PCN:V08-006-476103-0B

Product Change Notice

Polycarbonate-window protection implementation across all HEDX-9XXX devices.

**Without Polycarbonate
Window Protection**

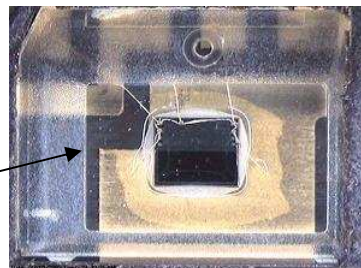
Polycarbonate-window protection is a part observed in customized devices and for all high temperature versions. This option will be implemented across all HEDX-9XXX devices.

To provide more robustness towards customer used applications resulted in Silicon coating and wire damaged.
